Proposed SE Elevation

A 110 002 - REV P2

NMA Application
01/11/23

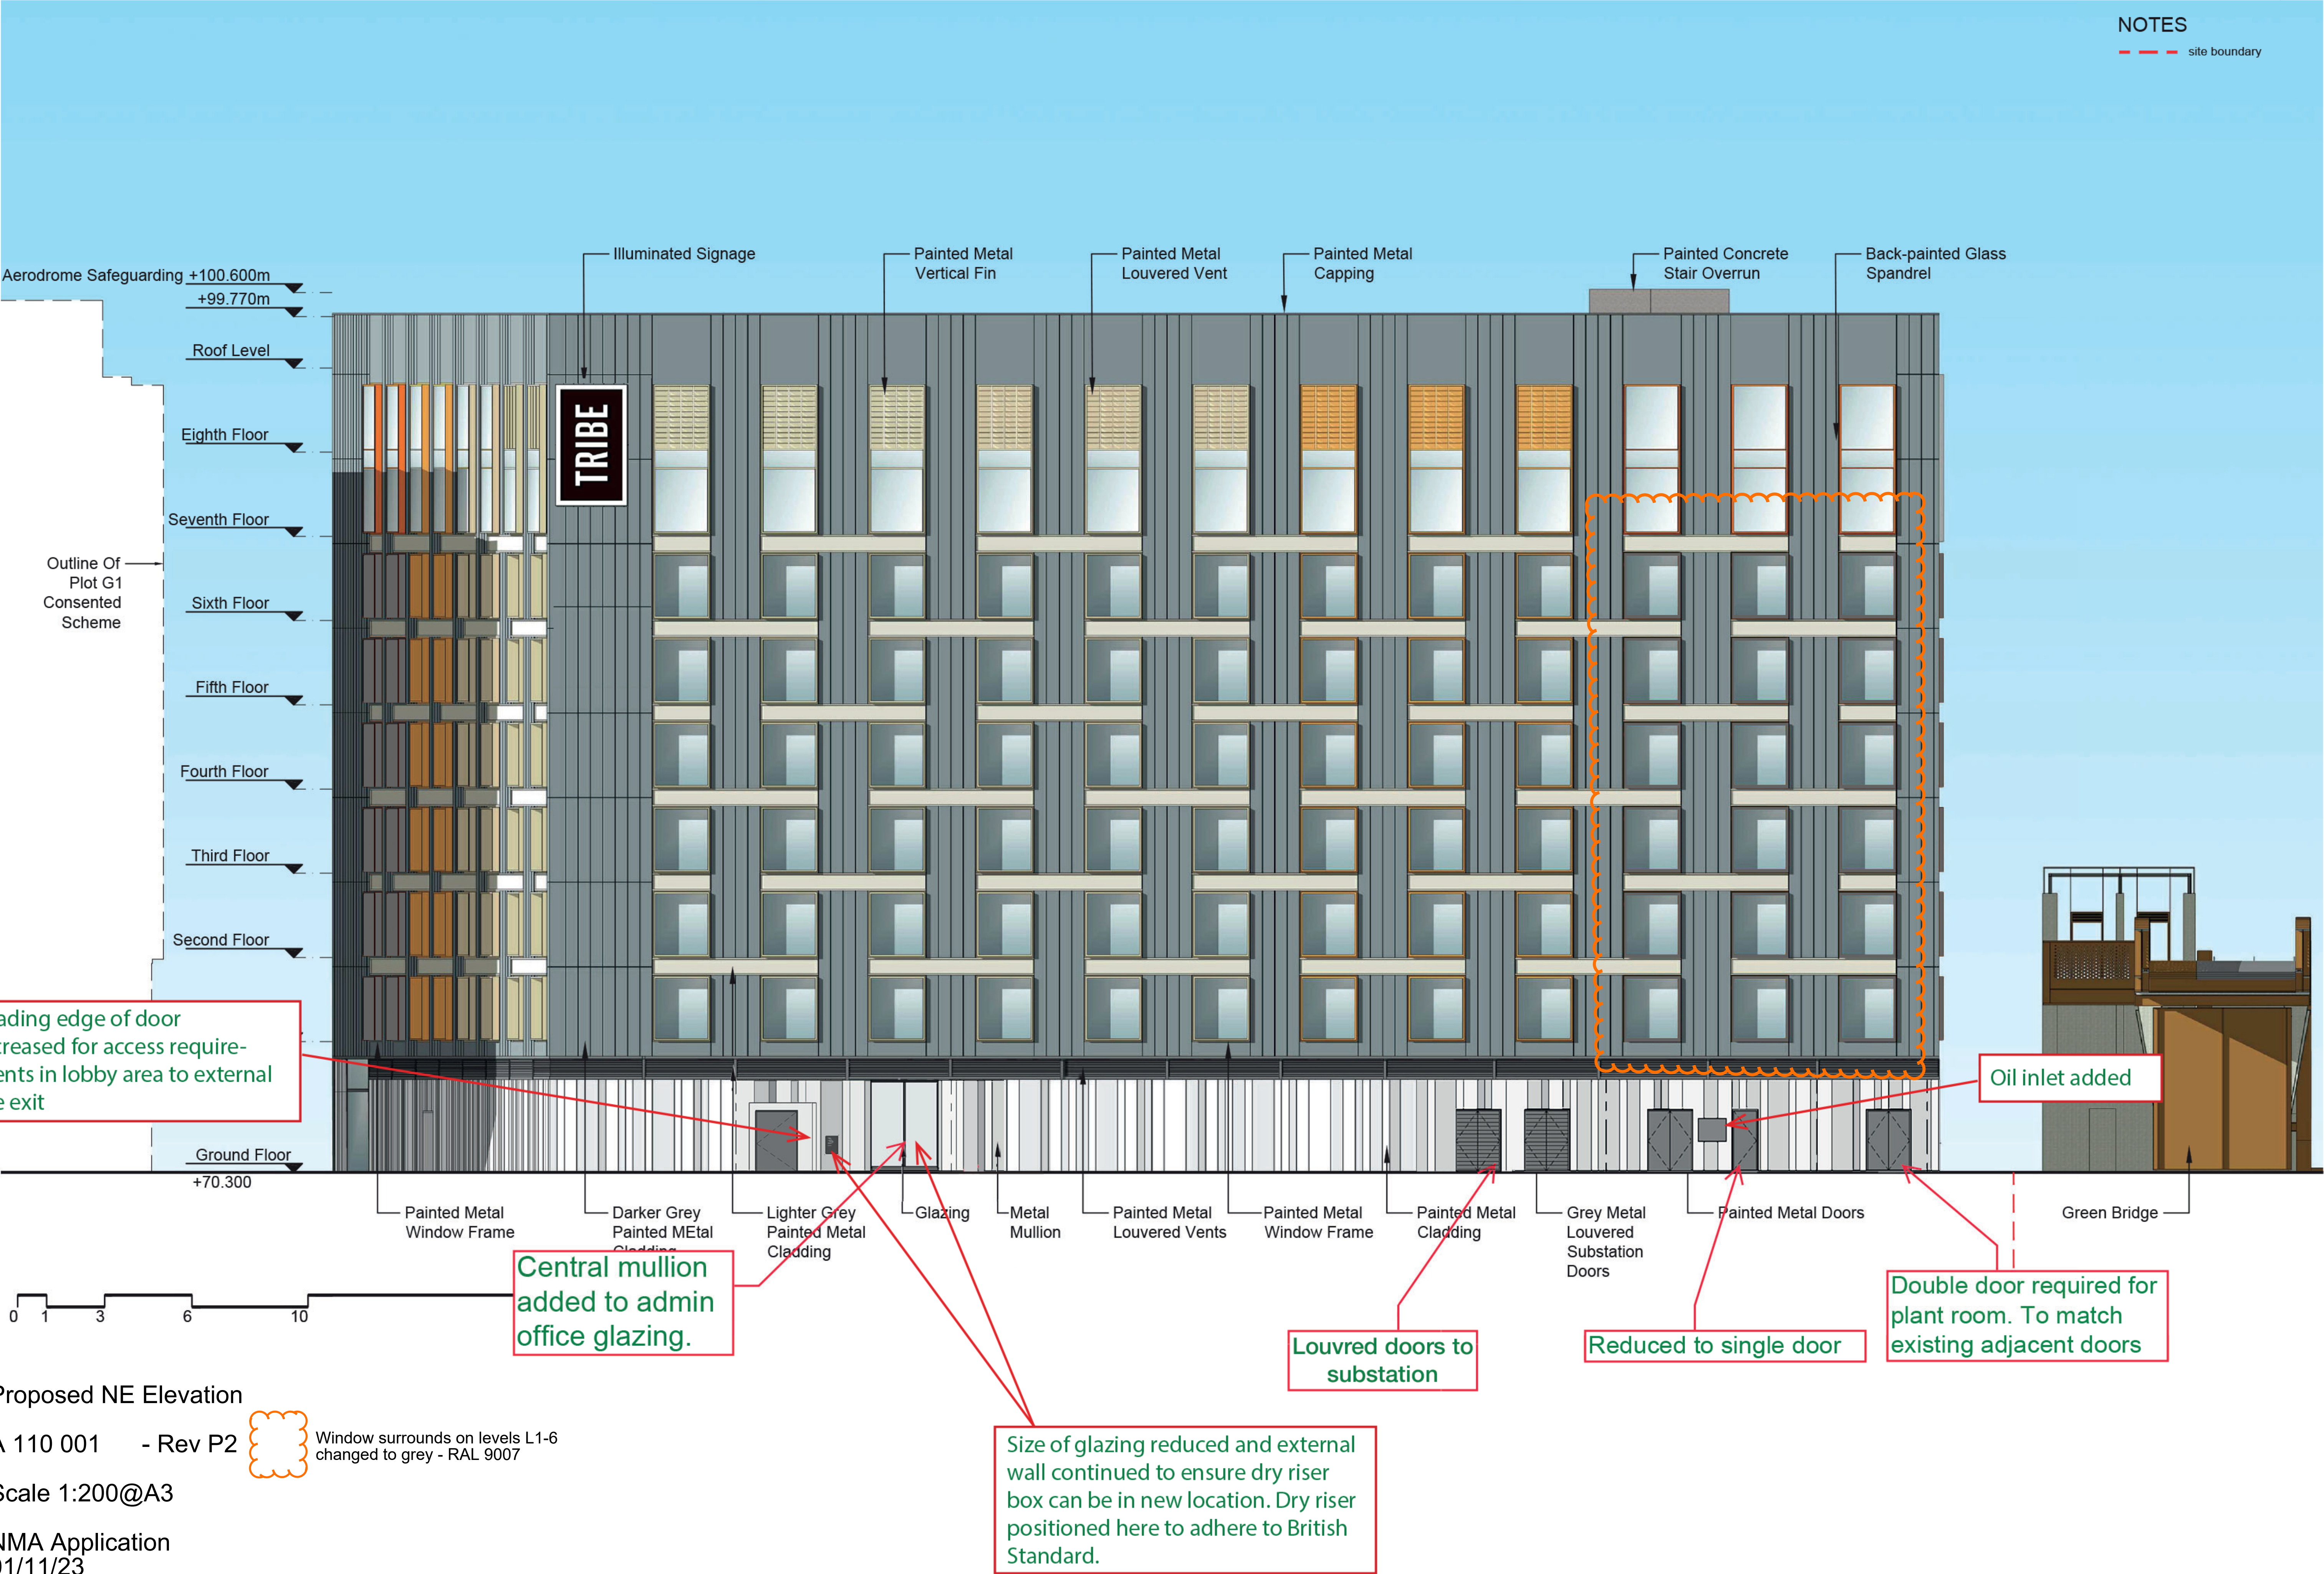
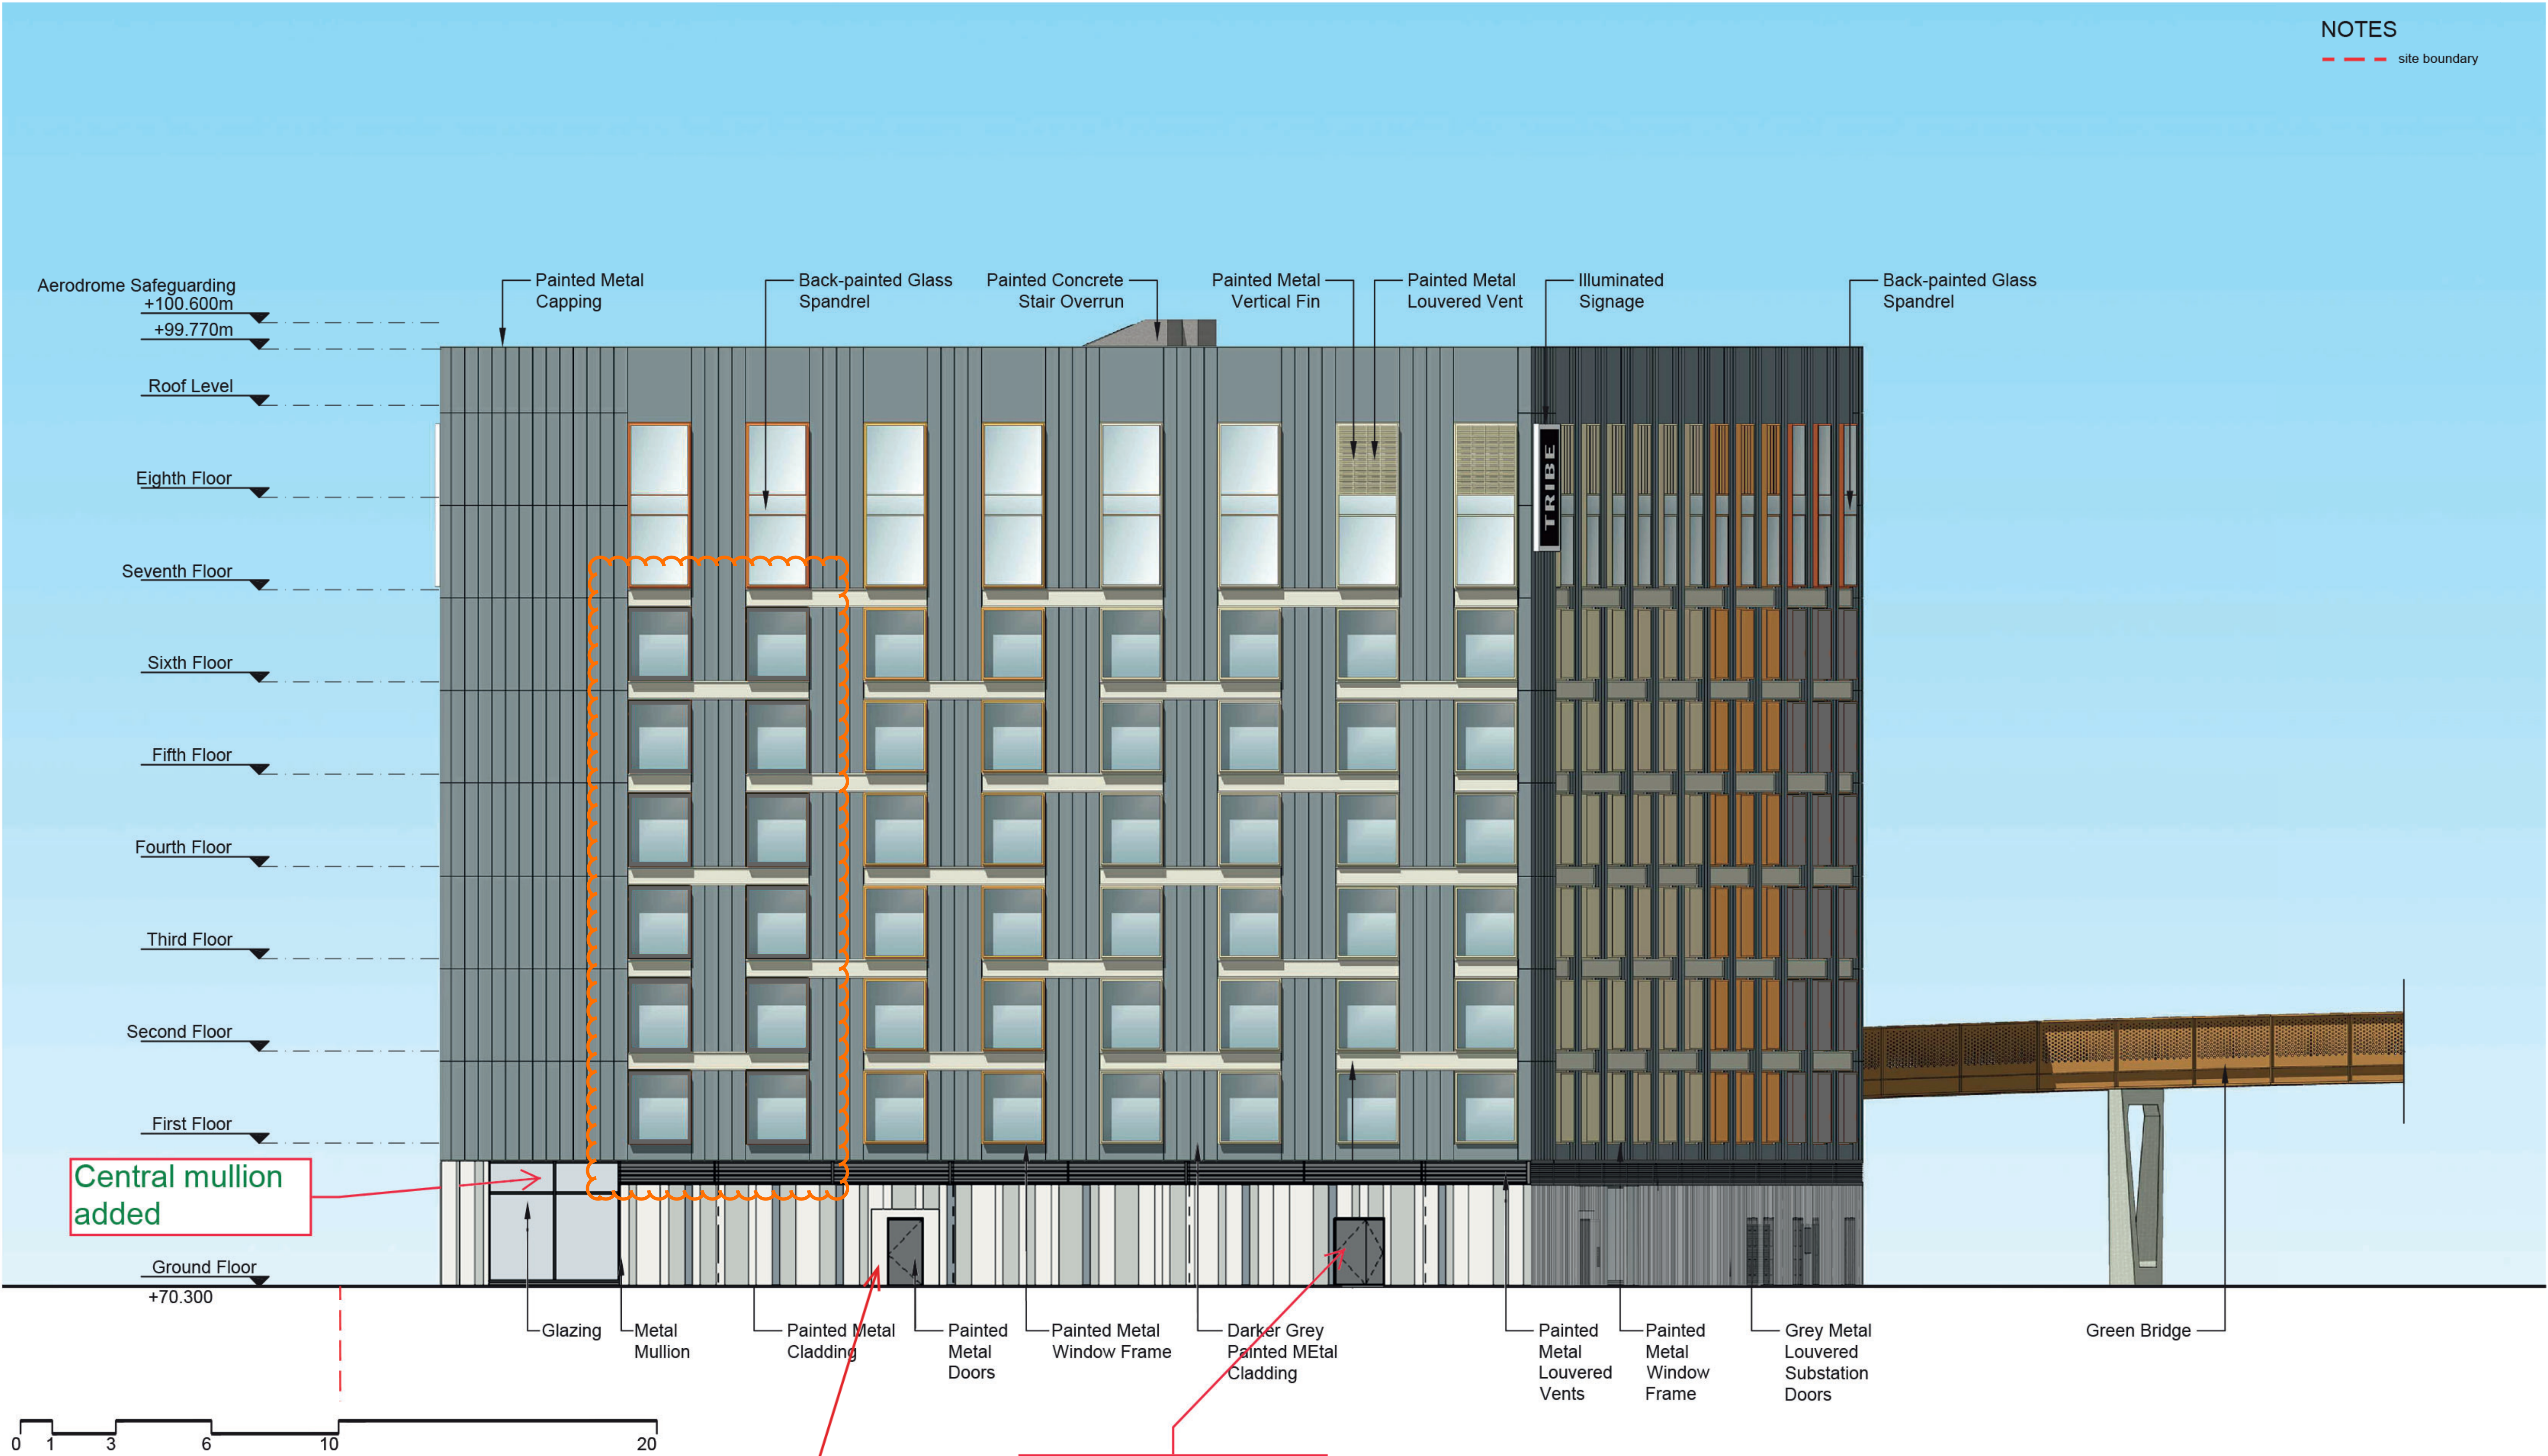
Window surrounds on levels L1-6 changed to grey - RAL 9007

Opening around door increased for access improvements into kitchen / refuse area

A 110 003 - Rev P3

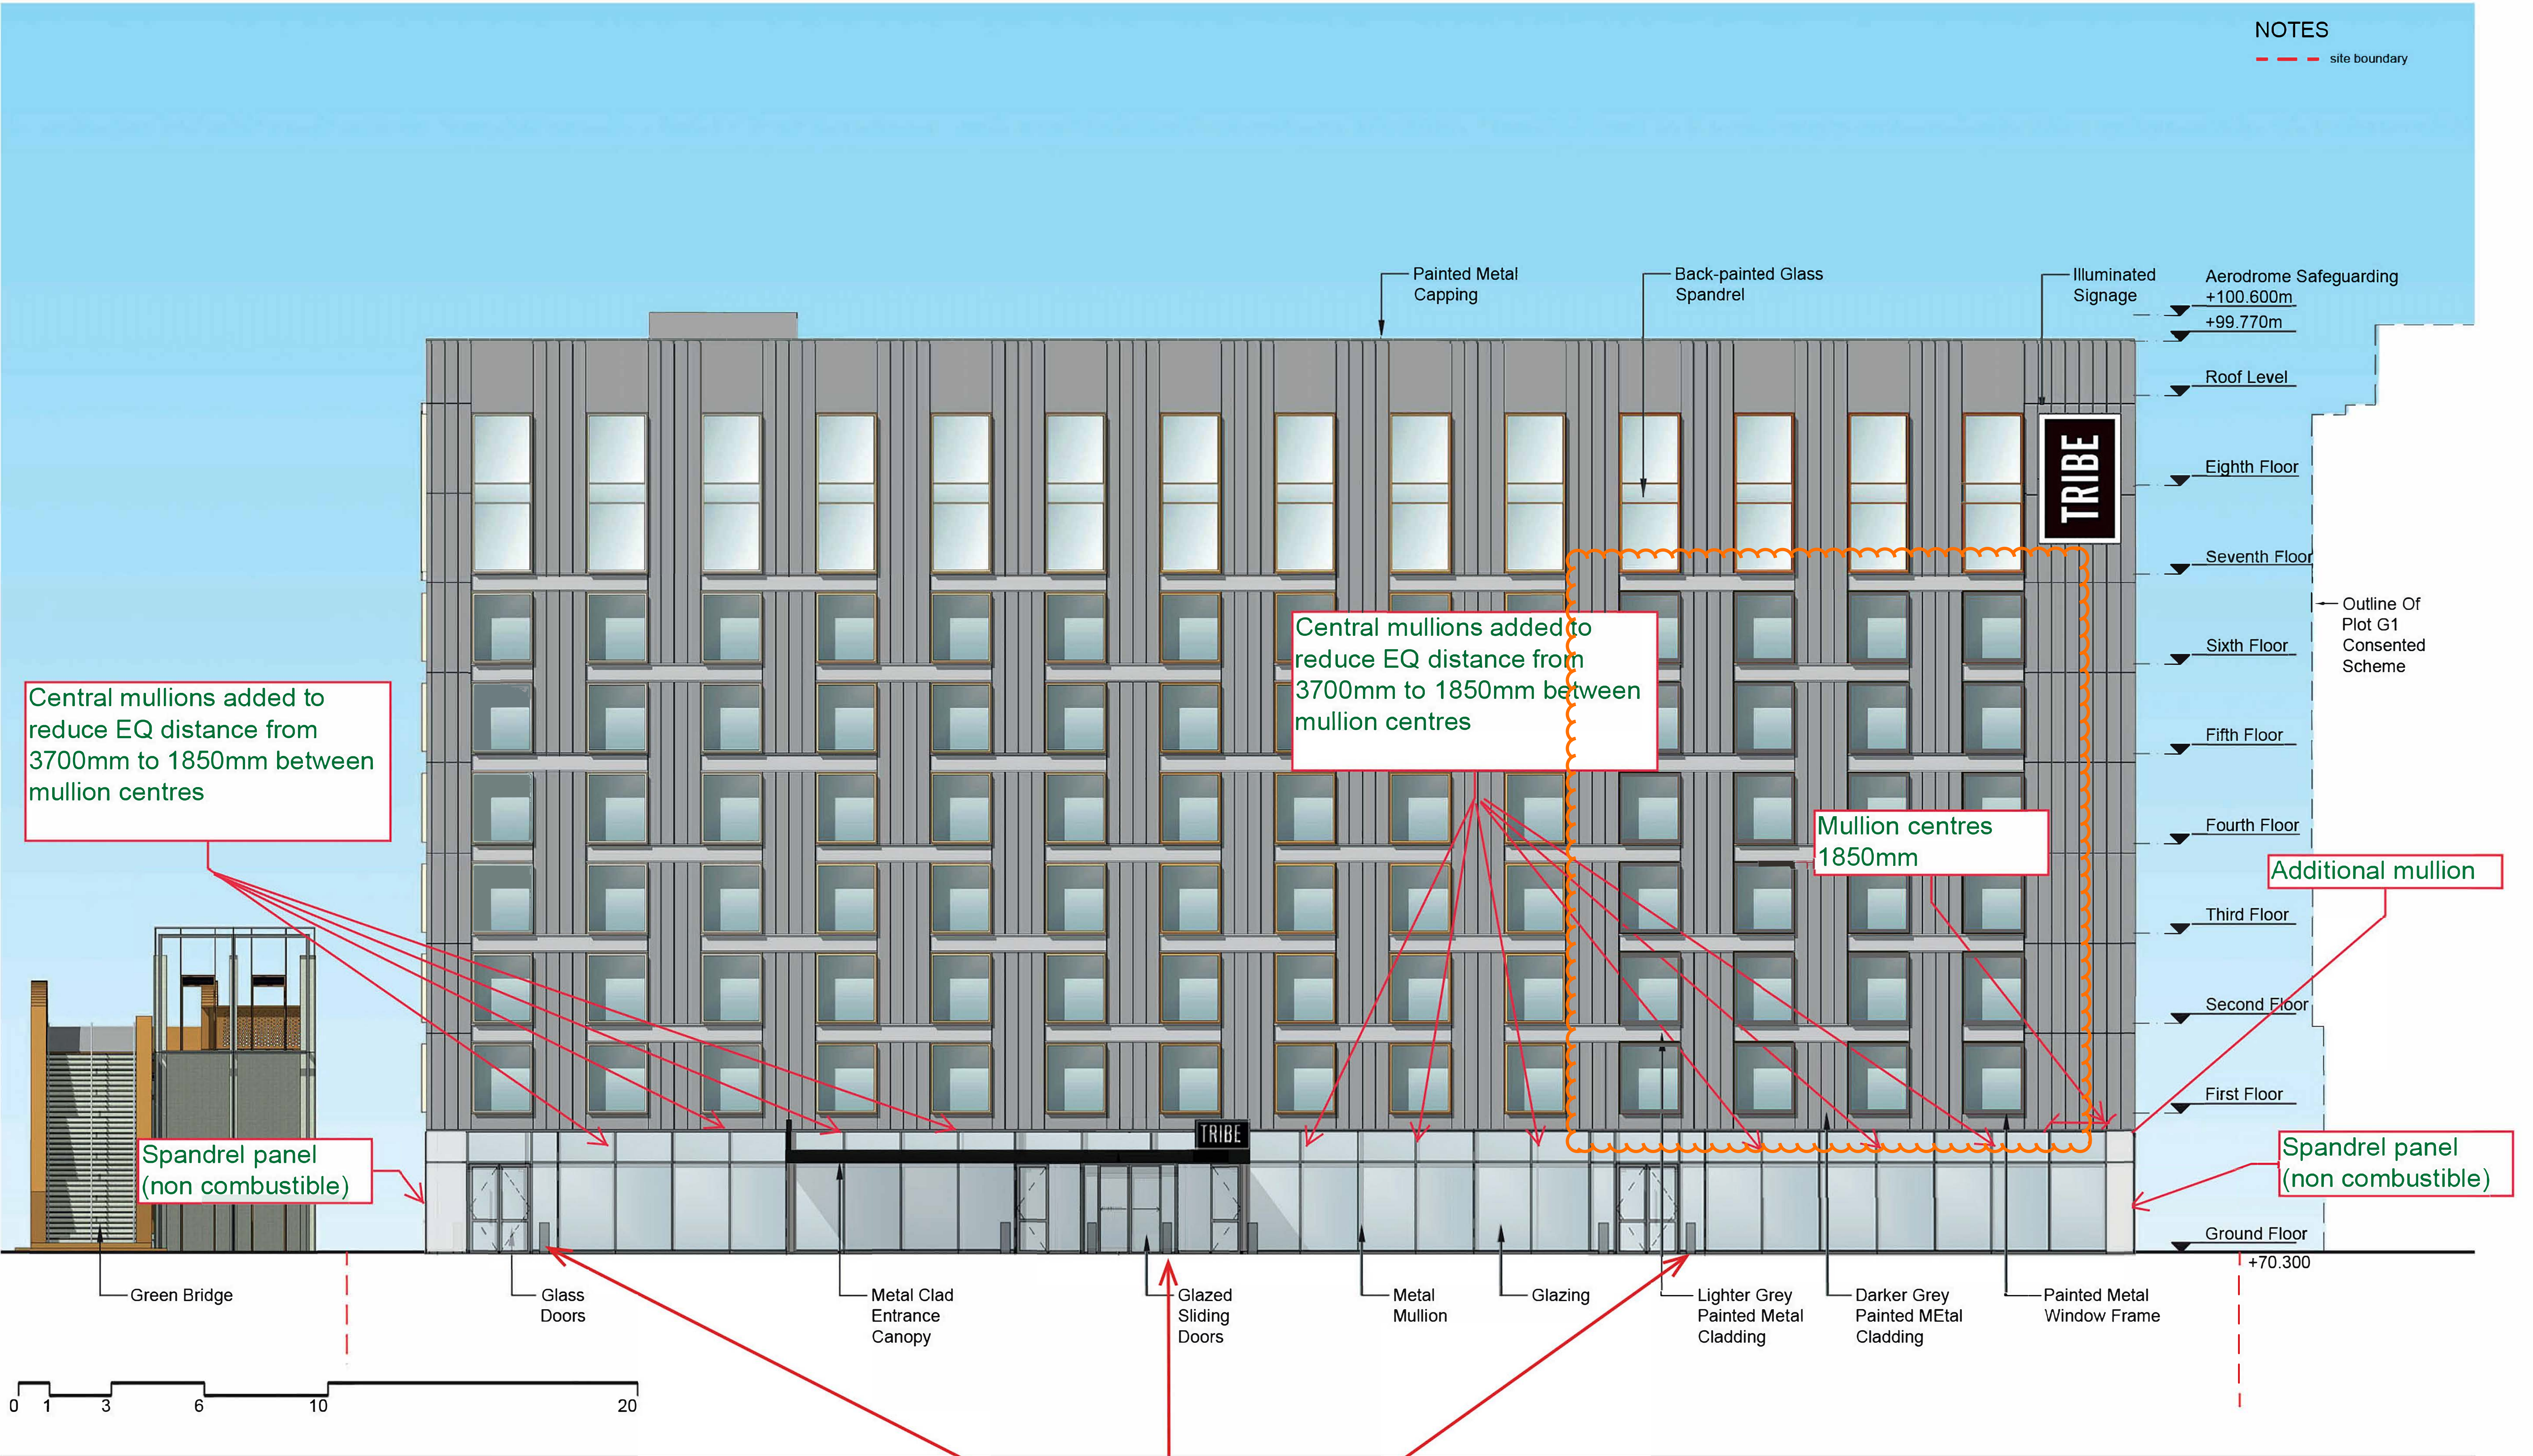
Double door required for plant room. To match existing adjacent doors

Window surrounds on levels L1-6 changed to grey - RAL 9007
